TTC Technical Committee Recommendations

Approved by NCUTCD Council January 12, 2008

**Figure 6H-1. Examples of Traffic Incident Management Area Signs**

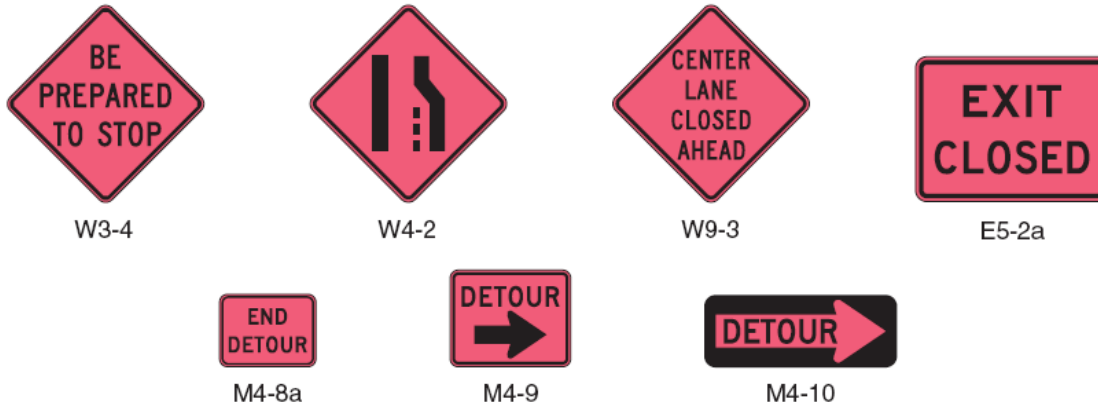
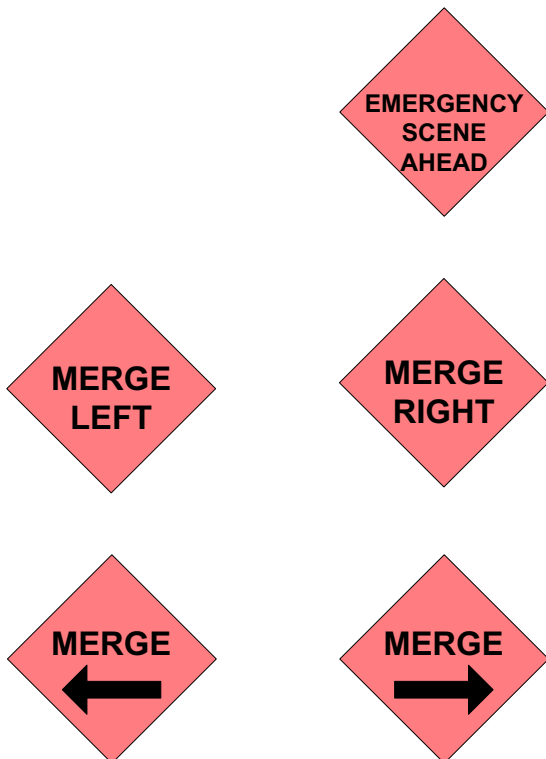
NPA Did Not Change the Figure, but TTC voted to add the following:

insert diamond signs: “EMERGENCY SCENE AHEAD” and “MERGE RIGHT/LEFT”
